Access Compliance Report

Public Rights-of-Way

(Curb Ramps)

Intersection ID: 45283	Main Street: ARWEN_RD	Cross Street: CIERA_NICHOLE_CT	Location:	N
ADA ID: 5234DBB4923A	Ramp Type: PerpDiag	Initial Pass/Fail: Fail	Overall Compliance: No	Severity Score: 42.5
Codes/Mitigation Info/Possible Solution		Field Measurements/Component Compliance

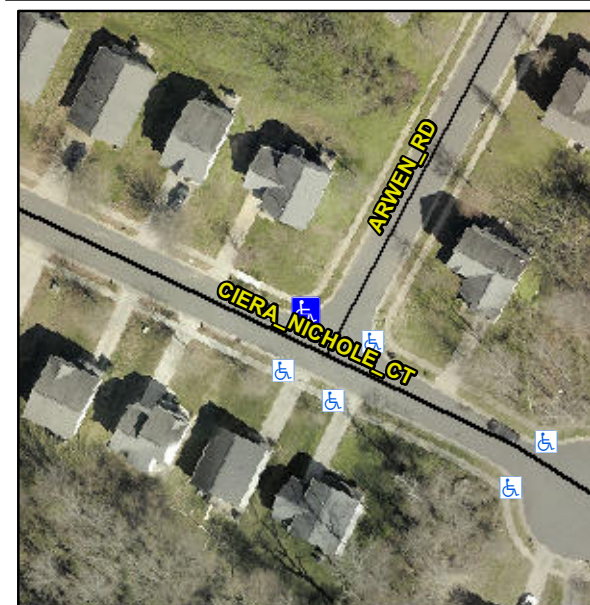
Not Found, R304.5.1, R304.5.3

Compliance	Description	Data	Compliance	Description	Data
N/A	Ramp Length (in)	47.0	Yes	Ramp Slope (%)	6.9
No	Ramp Width (in)	34.5	No	Ramp XSlope (%)	7.9
N/A	Flare Type LT	N/A	N/A	Flare Type RT	N/A
N/A	Flare Slope LT (%)	N/A	N/A	Flare Slope RT (%)	N/A
N/A	Flare Traversable LT?	N/A	N/A	Flare Traversable RT?	N/A
N/A	Landing Length (in)	N/A	N/A	DWS Provided?	N/A
N/A	Landing Width (in)	N/A	N/A	DWS Contrast?	N/A
N/A	Landing Slope (%)	N/A	N/A	DWS Length (in)	N/A
N/A	Landing X Slope (%)	N/A	N/A	DWS Full Width?	N/A
N/A	Landing Curb? (Y/N)	N/A	N/A	DWS Offset (in)	N/A
N/A	Shared Landing?	N/A			
N/A	Gutter Ponding?	N/A	N/A	Gutter Slope (%)	N/A
N/A	Gutter Lip Ht (in)	N/A	N/A	Gutter X Slope (%)	N/A
N/A	Painted X Walk1?	No	N/A	Painted X Walk2?	No
	X Walk 1 Direction	To SW		X Walk 2 Direction	To SE
N/A	X Walk 1 Width (in)	N/A	N/A	X Walk 2 Width (in)	N/A
	X Walk 1 Slope (%)	5.4		X Walk 2 Slope (%)	3.6
	X Walk 1 X Slope (%)	5.2		X Walk 2 X Slope (%)	5.3

Remove & Replace Curb Ramp With Two New Directional Ramps or Equivalent.
